REMARKS

VERSION WITH MARKINGS TO SHOW CHANGES MADE

FIG. 3

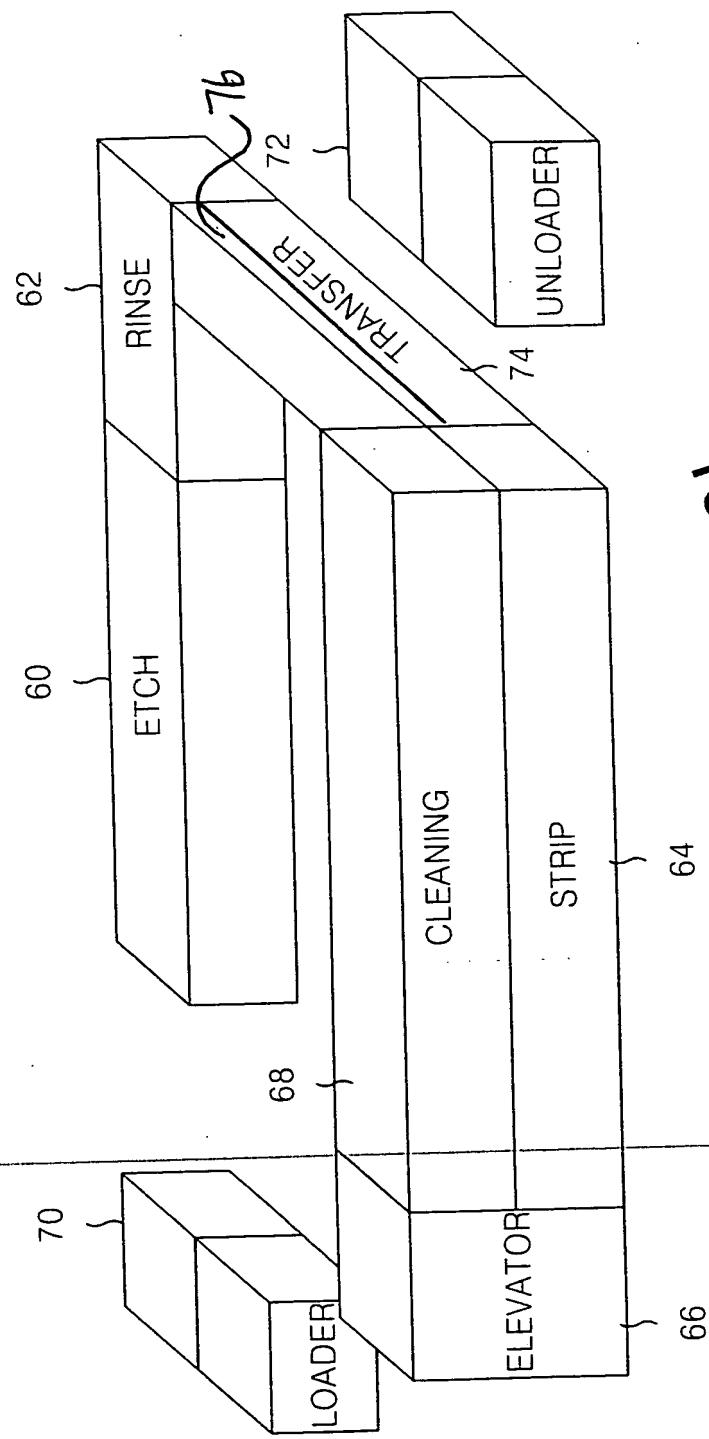
The Examiner objects to the drawings as not showing every feature of the invention specified in the claims. The Examiner asserts that the pipe shower must be indicated in the drawings.

The proposed amendments to Figure 3 show a pipe shower 76. The Examiner's attention is drawn to 37 C.F.R. 1.83(a) which states that "Conventional features disclosed in the description and claims, where their detailed illustration is not essential for a proper understanding of the invention, should be illustrated in the

--The substrate cleaned at the rinse module 62 is moved, via the transfer 74, into the strip module 64. The transfer 74 connects the rinse module 62 with the strip module 64 and includes a pipe shower 76 to prevent the substrate from drying. The strip module 64 strips the photoresist on the substrate using a stripper liquid.--
